# Architectural Review Board

Staff Report (ID # 9834)

**Summary Title:** 1700 and 1730 Embarcadero Road: Mercedes / Audi Dealerships (2nd Formal)

**Figure 1: Proposed Rear Elevation with Flow-Through Planters (January 2019)**

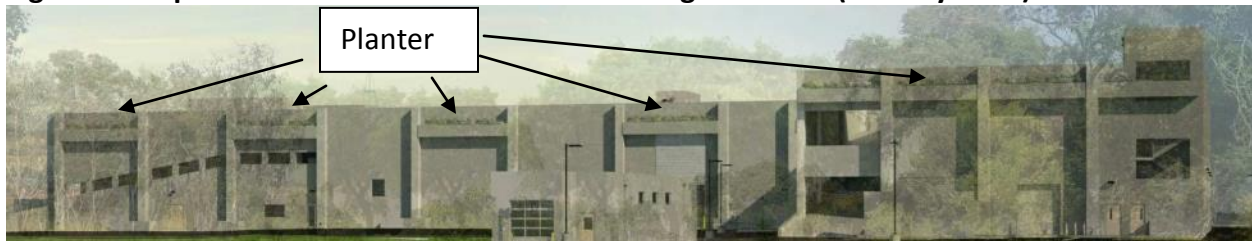
At the previous Board meeting, observations were made that the rear of the buildings did not have the same level of detail or quality of the street elevations. The elevation consisted of poured in place concrete that was painted white with the entire elevation lacking surface articulation. In response to the Board's concerns, the revised plans include an elevation that has a painted stucco finish and flow-through planter boxes integrated into the upper portions

Staff's position is that while the revisions are an improvement, they are insufficient. Staff recommends that the applicant return to the ARB Subcommittee to include additional elements and features on the rear elevation, including different materials and increased planting opportunities such as vines on screens affixed to the wall surfaces as suggested in Figure 3. These are photographs of real examples of treatment to parking structures using vegetation as screening.

7. **REAR ELEVATIONS:** The owner or designee shall provide revised architectural treatment for the rear of the buildings to add more variety in materials and articulation.

**Figure 9: View of Automated Vehicle Stacking System on First Floor**

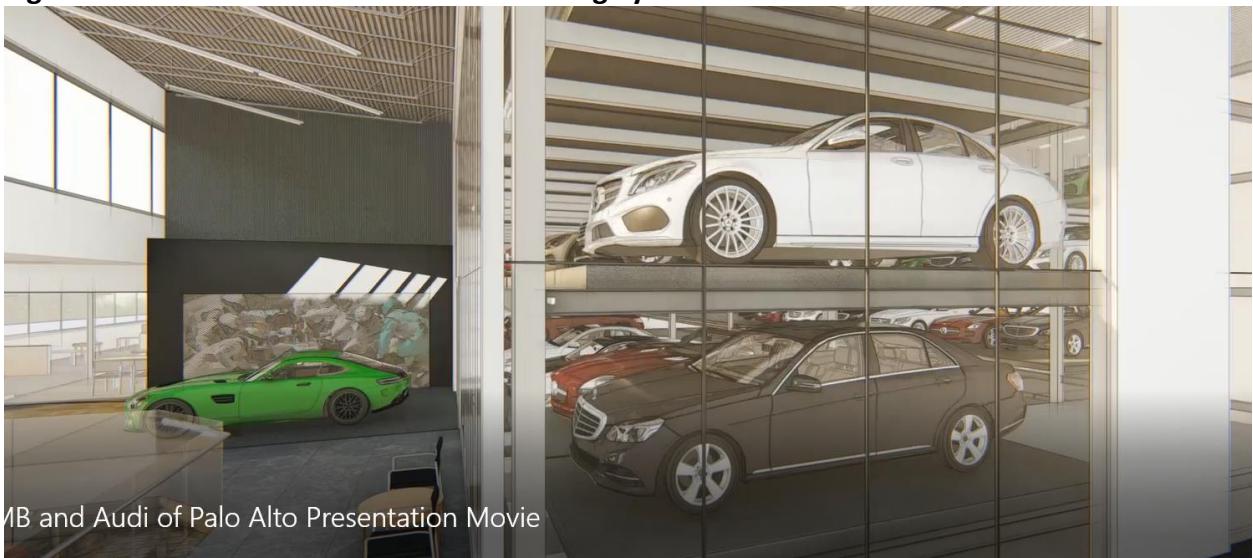
The project is consistent with the City's FAR requirements. The municipal code limits the floor area and height of showroom space. The project is well below these thresholds. The new car inventory building is located within a high-volume building that includes a puzzle lift system for vehicle storage. Floor area is calculated based on the number of floors in the building. This portion of the building only contains one floor on the ground level, portions of a second floor along the periphery of the building, the rest of the building area is volumetric space. The vehicle stackers add capacity, and some might consider this enhanced capacity as floor area, but the interpretation made for this project differs from that perspective. Accordingly, staff wanted to bring the ARB's attention to this interpretation and can provide additional information at the hearing as warranted.
